# Problem Report

Report Number: 4

Project Name: TeraPixel APS for CALICE

Item: HiPoly resistors in preShape pixel

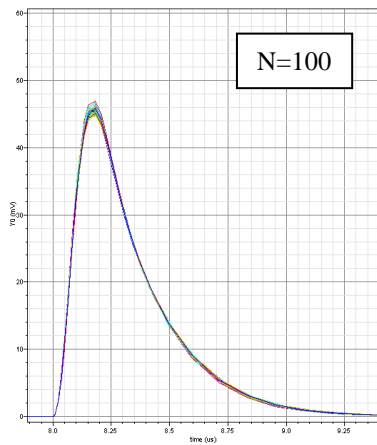
After trial verification with the calibre LVS tool it appears the original design was manufactured with the incorrect values of hi-resistance poly resistors. The schematic and layout “pcell”, (which automatically generates the width/length of the resistor from the resistance value entered), created resistors that were physically too short. The assura rules used at the time did not report this error, but new calibre rules report the parameter mismatch, and the spice documentation lists the unit resistance for hi-poly resistors such that it agrees with the calibre result.

Calculating the new value for the  $4M\Omega$  feedback resistor gives a value of  $2.7M\Omega$ . Typical shaper output is shown for the original and newly calculated are shown below in red & blue respectively.

Green trace in previous plot shows the 3.3M case, which is an improvement on original design, but not full designed performance. No larger resistor can fit in the pixel with all other changes implemented.

Clearly the recommended resistor width is impractical in the pixel – in fact keeping the original 2.7M resistance value and boosting width to improve matching can only fit an additional .03 $\mu$ m width before using the full available area in the new pixel design – hence improvement to matching from this option will be negligible so recommend increase to length as most appropriate course of action.
